**GENERAL
ELECTRIC
COMPANY
MAJOR
APPLIANCES**

Service Bulletin — REF 7-90

**DRAIN FREEZING
TMNF 14/16 "M" MODELS**

DATE: August, 1990

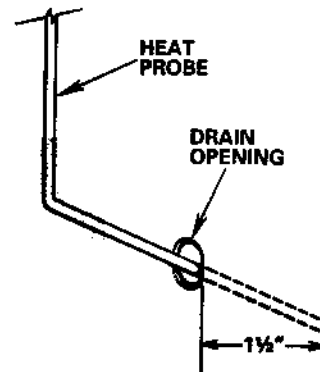
Water dripping from the air diffuser at the top of the fresh food liner, in some early produced TMNF 14 and 16 "M" (1990) models, is likely caused by defrost water overflowing the drain sump due to ice forming in the drain opening.

This condition was corrected at the factory in February, 1990 by adding a heavy aluminum wire probe to the defrost heater shield. The probe, riveted to the front of the shield and extending down into the drain opening, conducts heat from the defrost heater to prevent the formation of ice in the drain opening.

This correction can be applied in the consumer's home by replacing the original defrost heater shield. The WR2X8350 Replacement Shield has the heat probe attached. When installing the shield, be sure the probe is positioned into the drain opening approximately 1 1/2-inches. The probe should be centered in the drain opening and not touching any plastic surface. Wipe the heater glass with a damp paper towel to remove contaminants after handling.
